PROJECT: Ferndale Terrace Project

City Project SW2016-01; TIB Project Number 8-2-985(011)-1

**ADDENDUM NO. 3**  
To the Contract Documents for:  
City of Ferndale, Washington  
FERNDALE TERRACE PROJECT  
City of Ferndale Project No. SW2016-01; TIB Project Number 8-2-985(011)-1

DATE 1/31/25  
SHEET 1  
of 85

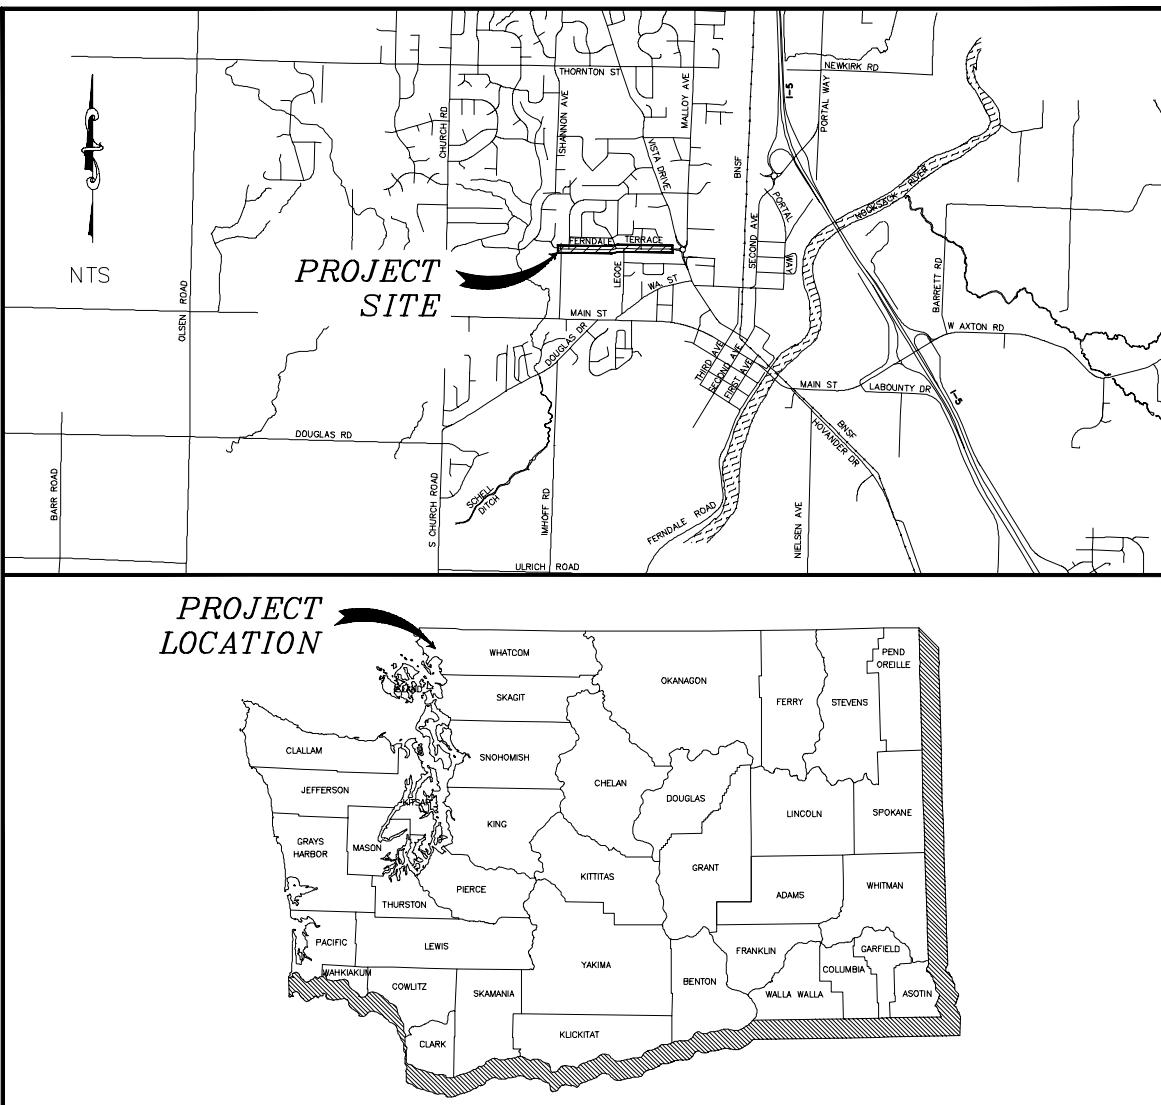
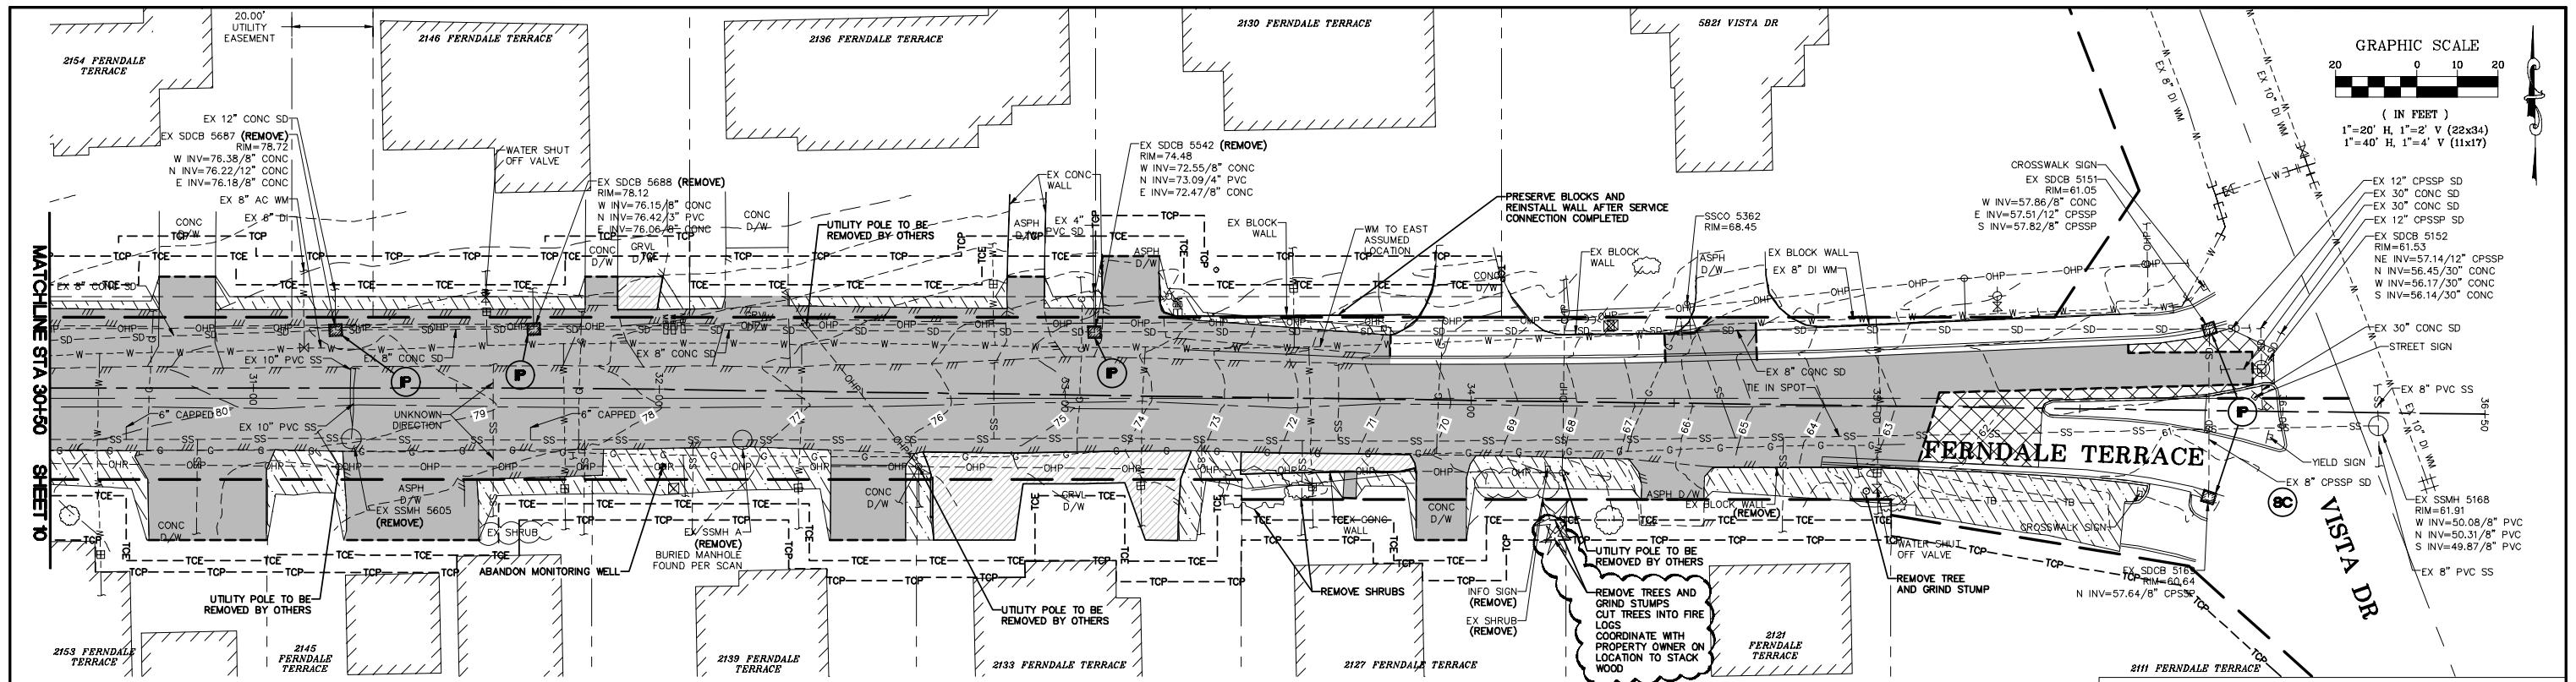
Sheet 1, sheet index updated to include added sheet 37A.

1/31/25  
ET 11  
of 85

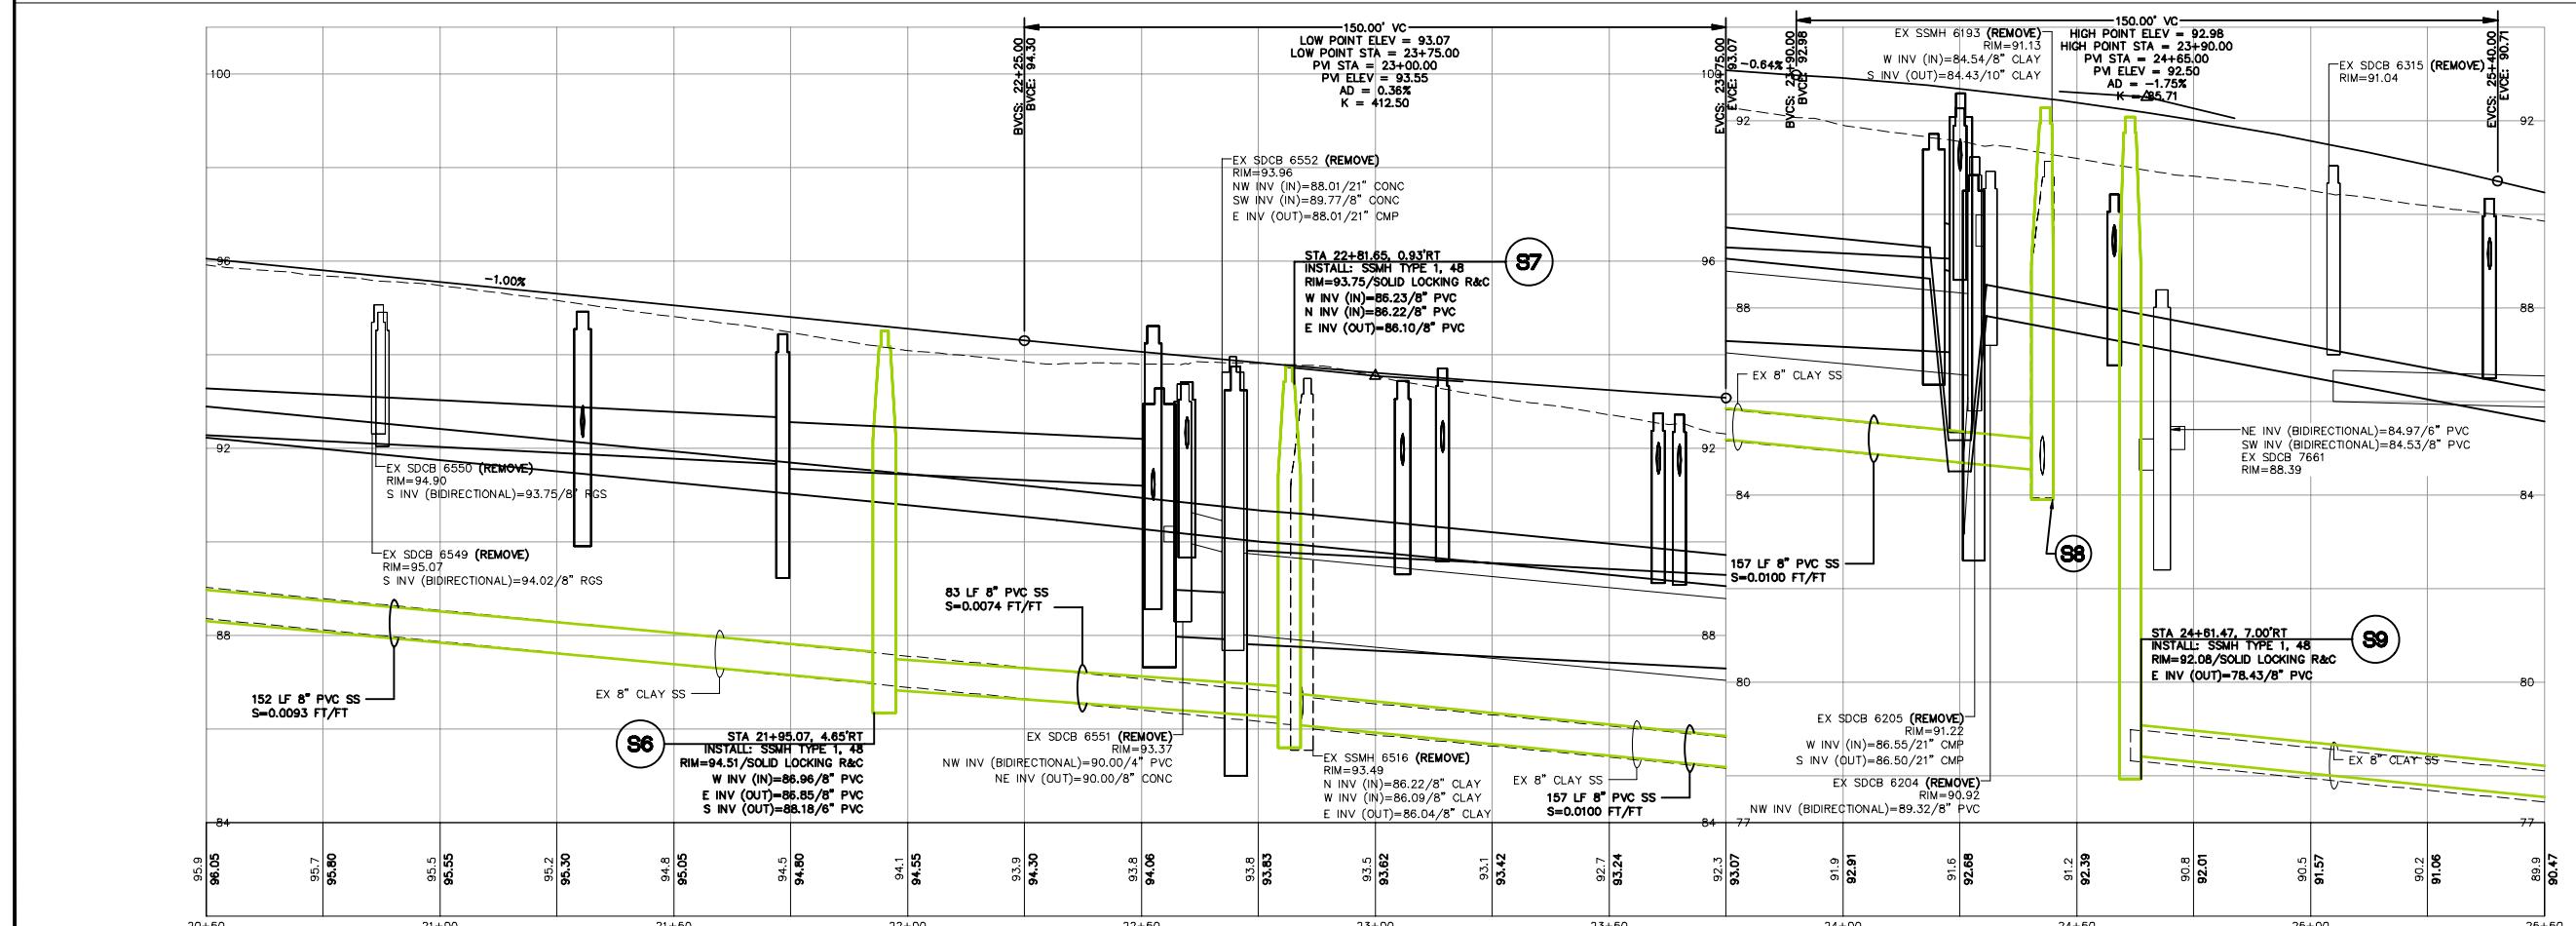
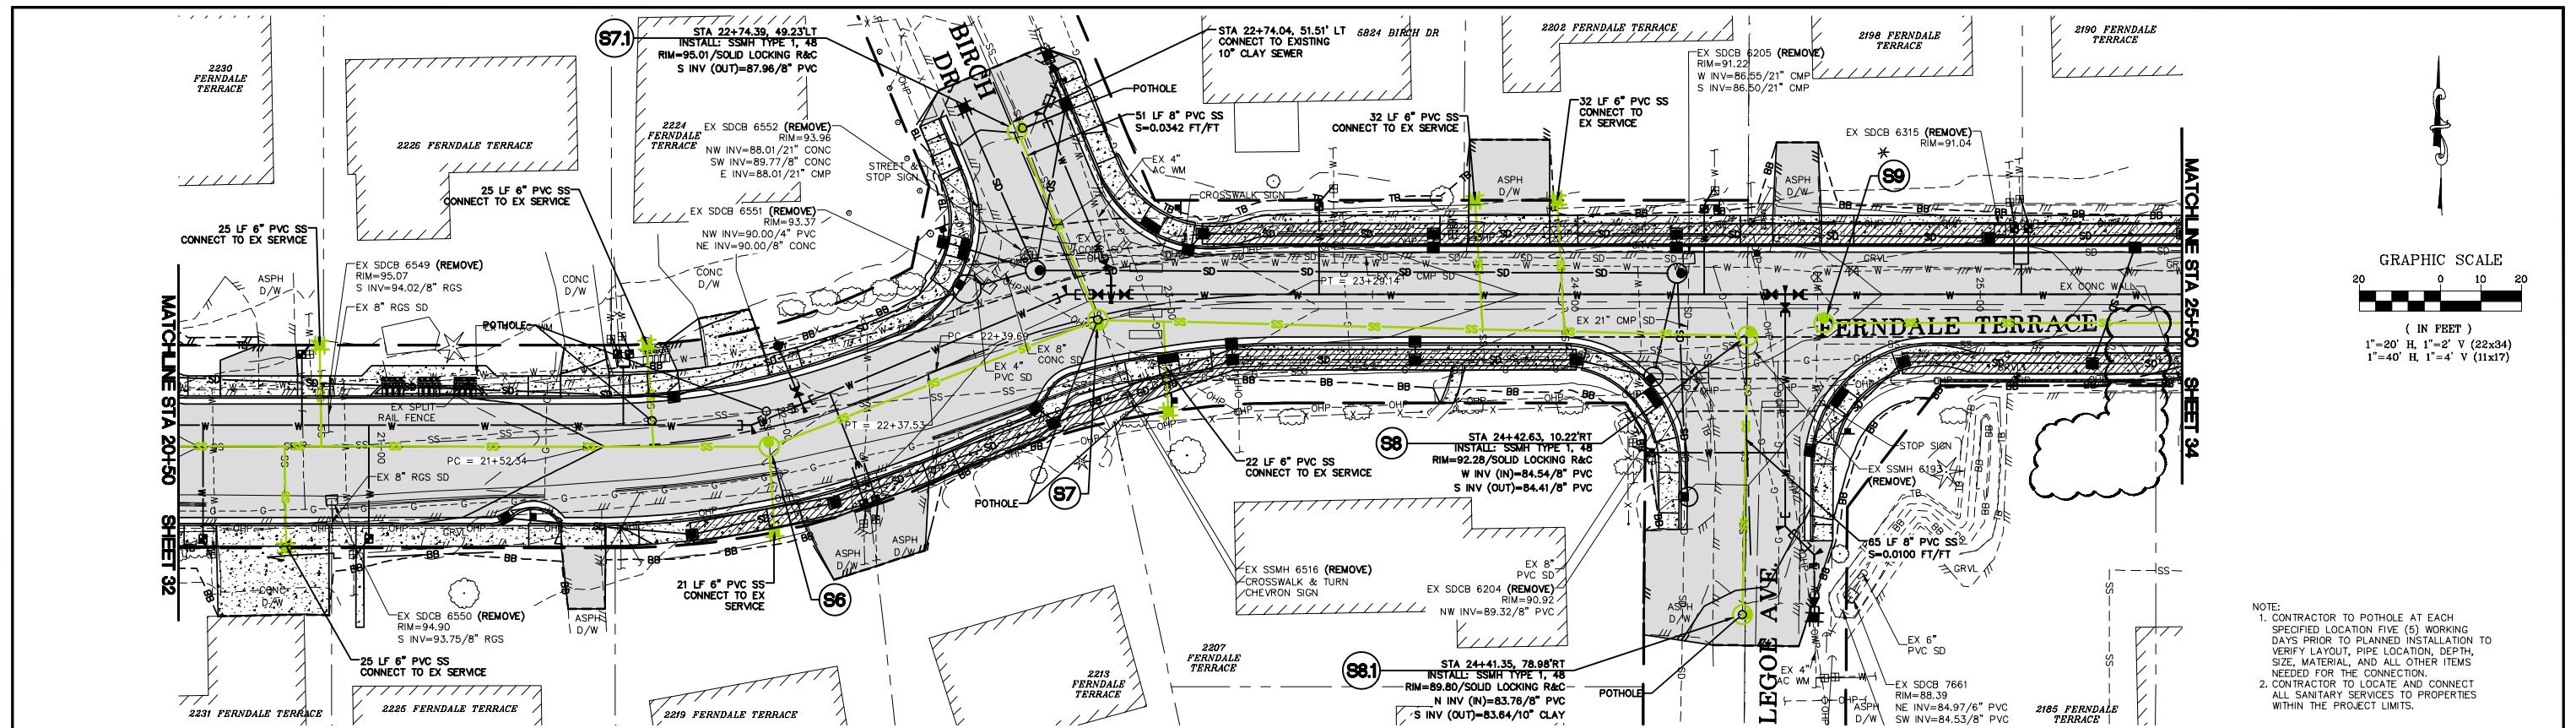
Sheet 11, an additional tree at approximately STA 34+20, RT, was added to the demo plan.
